SUBJECT: Provides response to request for addl info re main stream isolation valve/alternate leakage treatment sys. *see Reports*

**SUSQUEHANNA STEAM ELECTRIC STATION
MAIN STEAM ISOLATION VALVE/ALTERNATE
LEAKAGE TREATMENT SYSTEM : FOLLOW-UP RESPONSE
TO REQUEST FOR ADDITIONAL INFORMATION
PLA-4303**

Docket Nos. 50-387
and 50-388

Figure 9 - 1

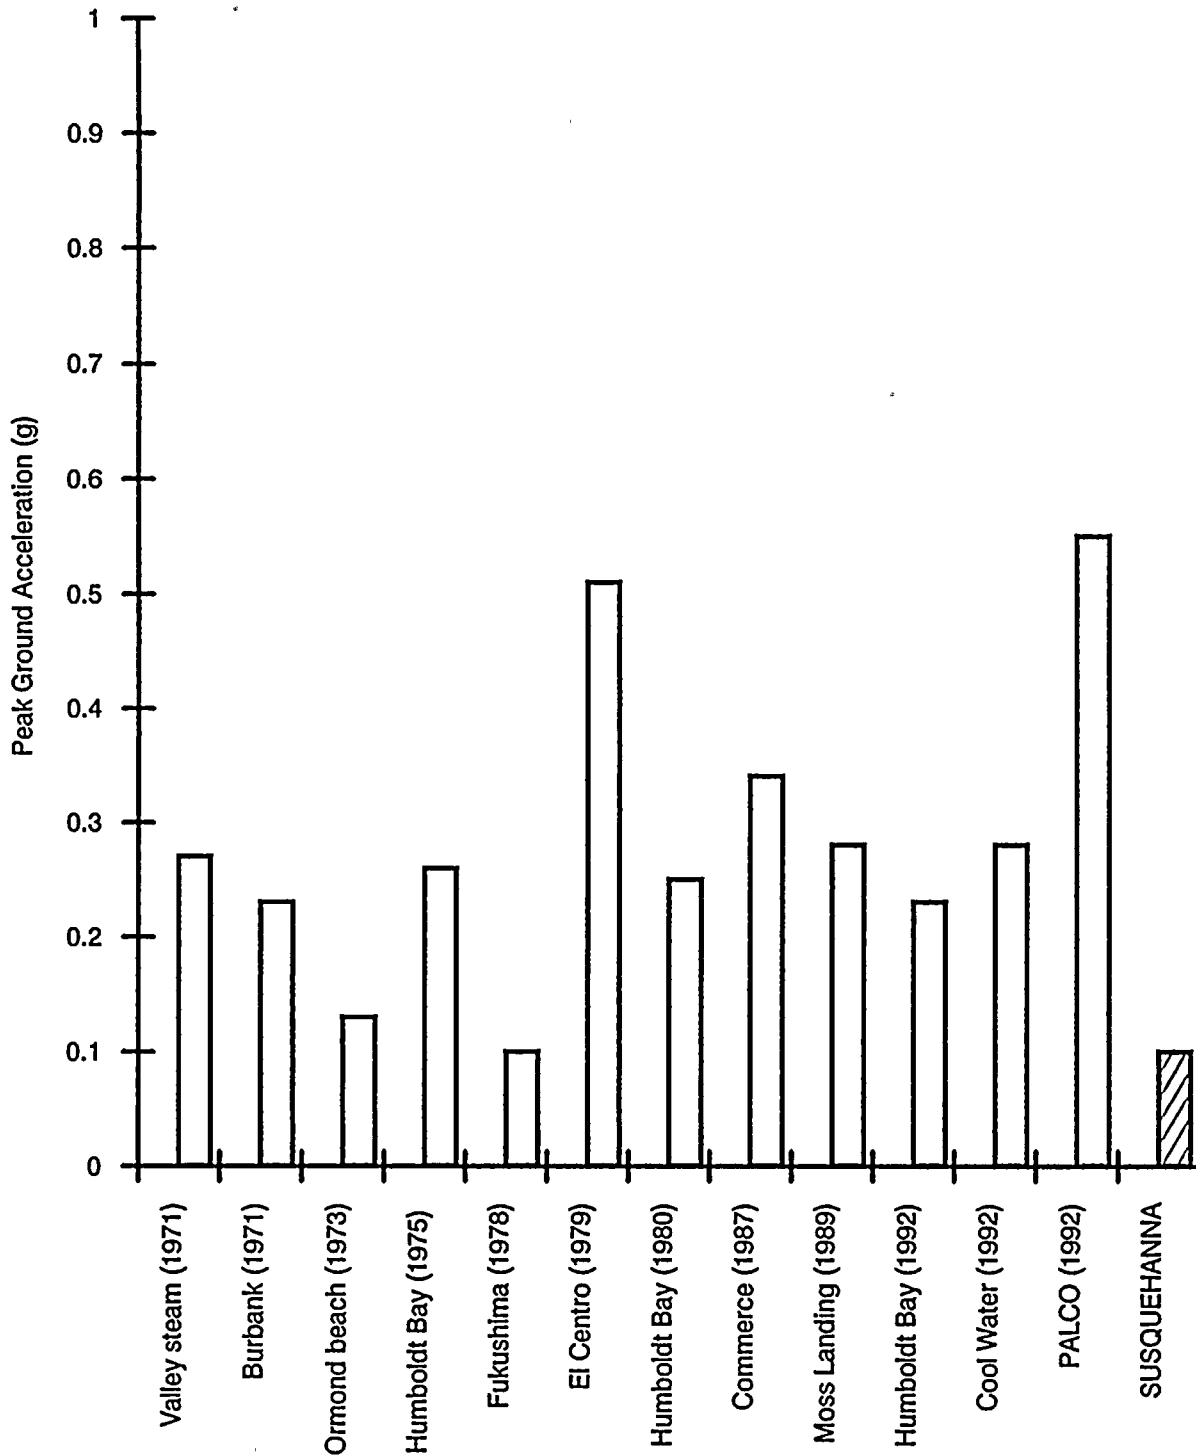
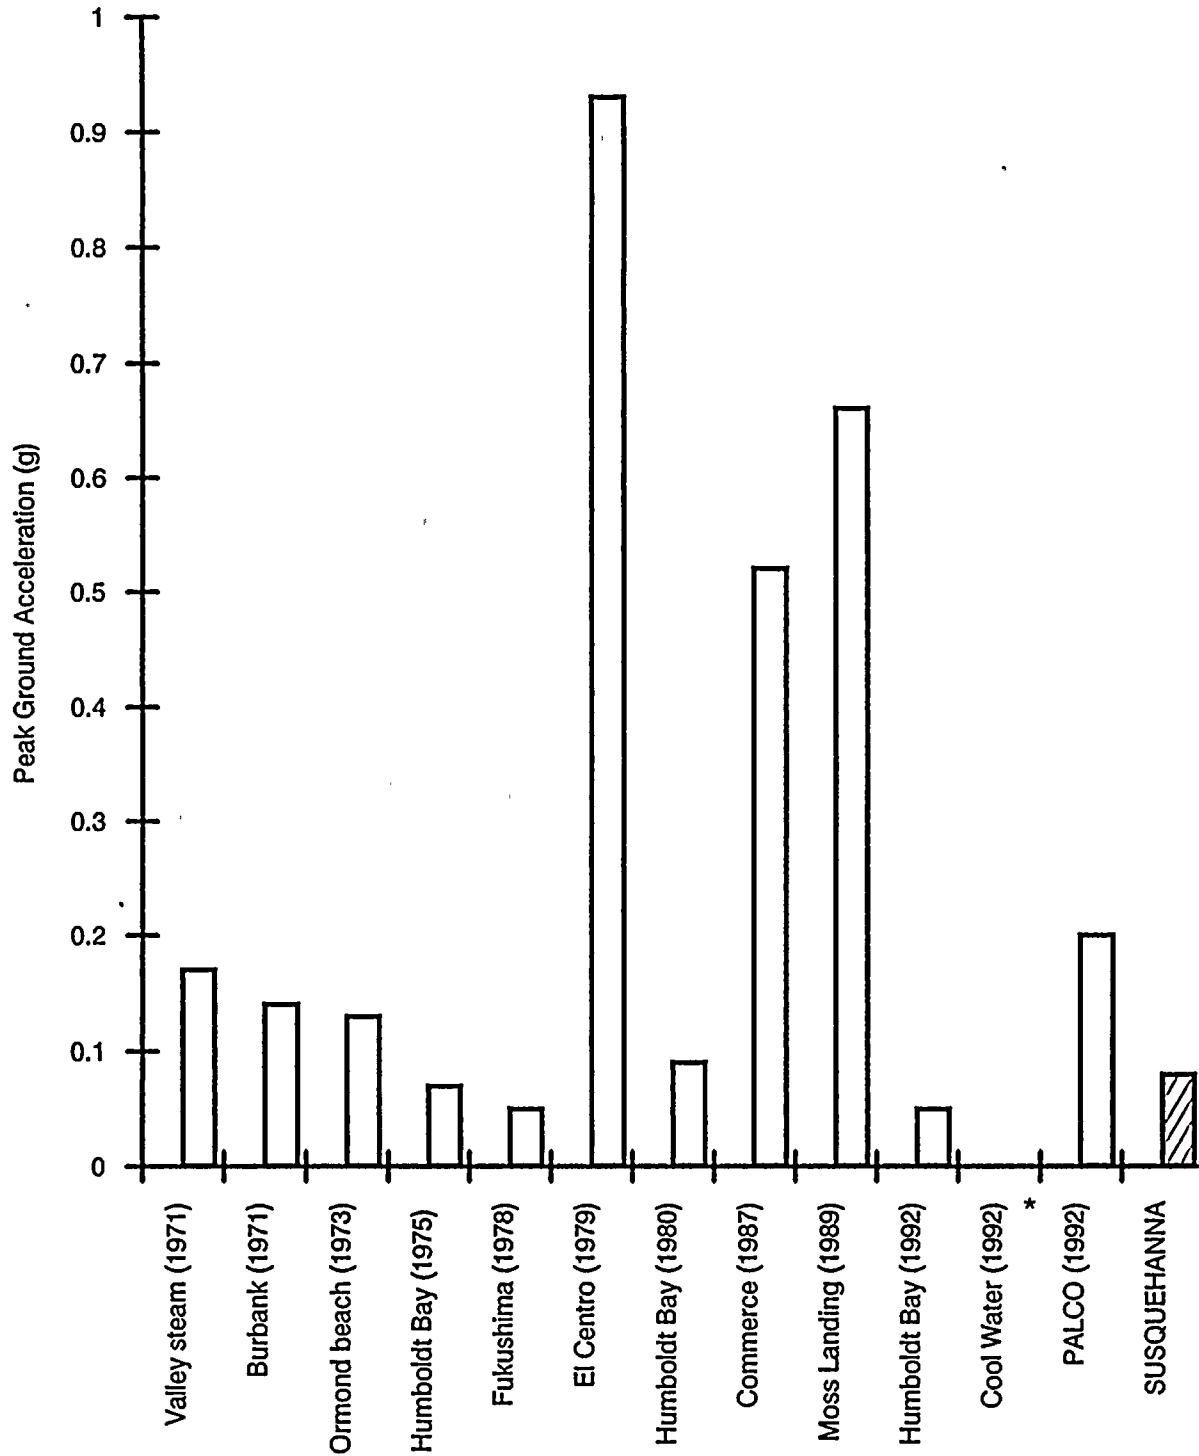
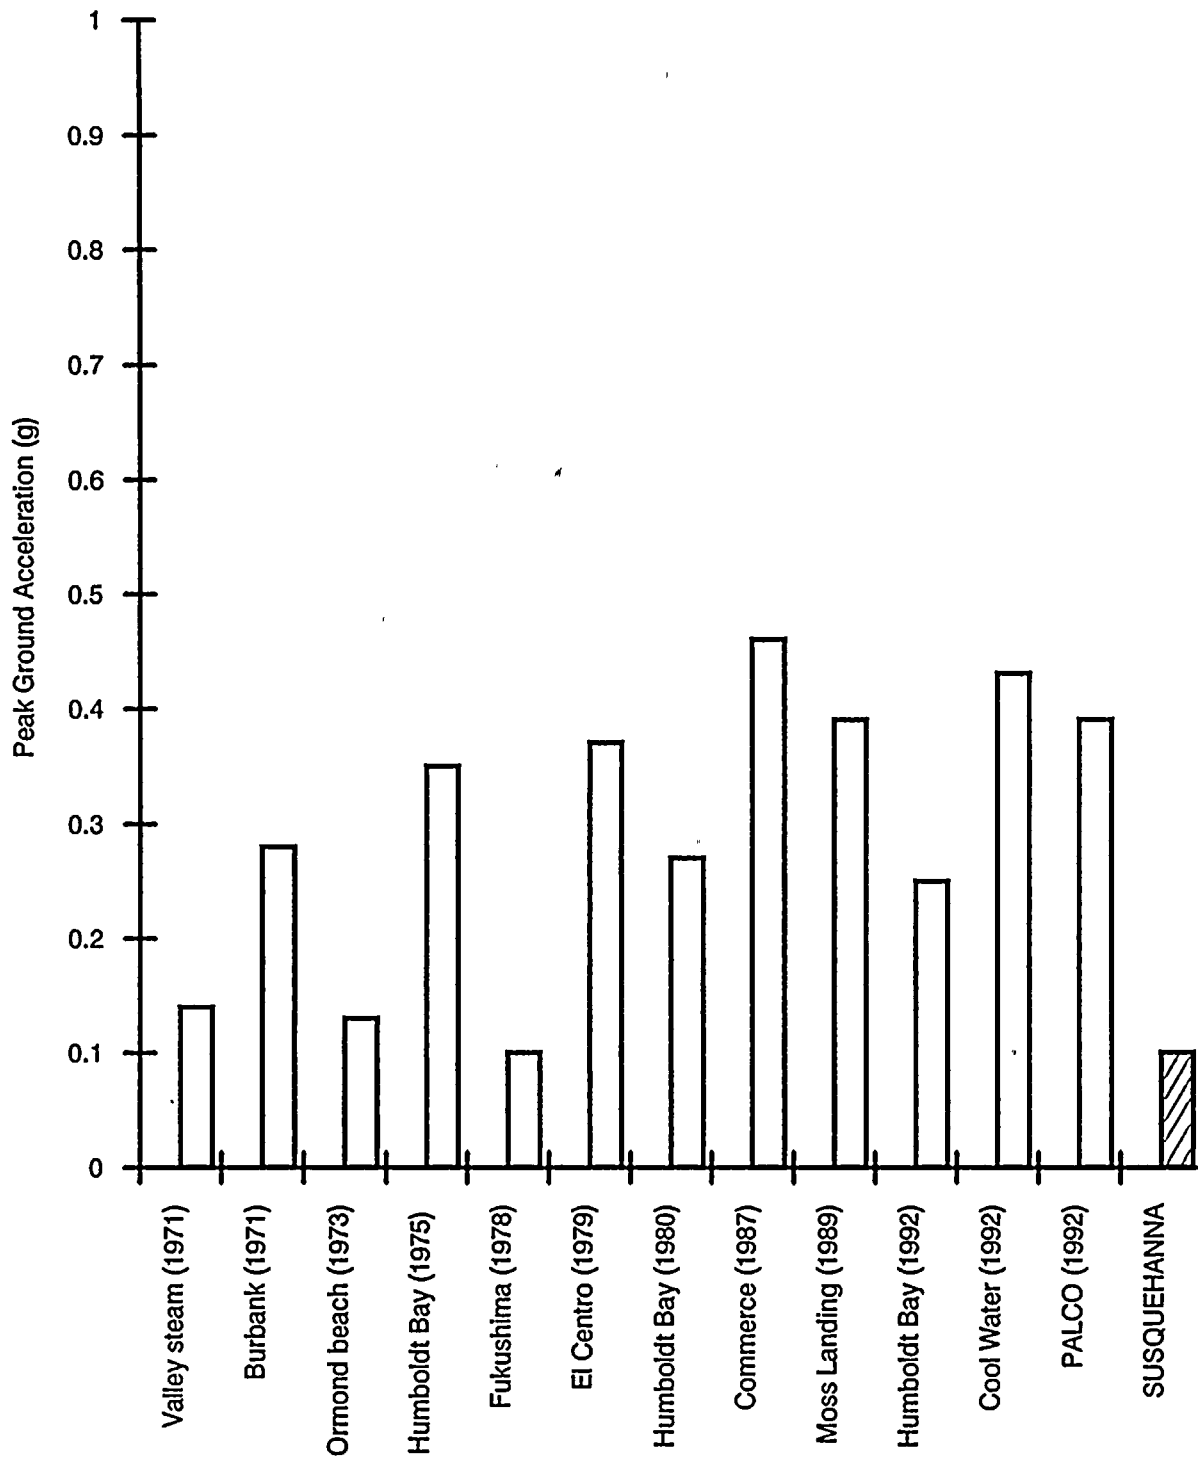
For each of the earthquake-facility pairs in the experience database which are being relied upon to demonstrate the seismic adequacy of the ALT system for Susquehanna provide the following information:

- a. The name, location (latitude and longitude), and foundation geology (i.e., rock, deep soil, shallow soil) of the facility.
- b. The name, date, time, epicenter, magnitude of the earthquake and the distance from the facility to the earthquake rupture.

- c. The five percent of critical damping response spectra of the ground motion estimated at the facility from the earthquake.
- d. The method used to estimate the ground motion at the facility. If the ground motion is based on actual ground motion recordings, provide the location (latitude and longitude) and foundation geology of the recording station and its distance from the facility and its distance to the closest part of the fault rupture. If the estimation is based on a method other than an actual recording of the earthquake ground motion or if the recording station is not collocated with the facility, describe the method used to estimate the ground motion in detail and provide any ground motion attenuation equations which may have been used to obtain the estimate.

The earthquake-facility pairs in the experience database which are being relied upon to demonstrate the seismic adequacy of the ALT system for Susquehanna are listed in Table 9 - 1 along with the estimated peak ground acceleration. The facility name, location, approximate distance from the facility to the epicenter, the approximate distance from the facility to the seismic instrument, the facility site soils, and the instrument site soils are provided for selected sites in Table 9 - 2. Specific information in regard to latitude and longitude of the database facilities is not available. The facility, earthquake date and time, magnitude of the recorded ground motions, and the method used to estimate the ground motions is provided in Table 9 - 3 for selected sites. Comparison of the recorded earthquake motions for selected database facilities with the Susquehanna design basis earthquake is provided in Figures 9 - 1 to 9 - 3 for north-south, vertical, and east-west directions, respectively. Another comparison is provided in PLA 4228, dated November 21, 1994, for ground motion response spectra. Both comparisons highlight the low SSES seismic demand relative to the recorded database earthquakes.
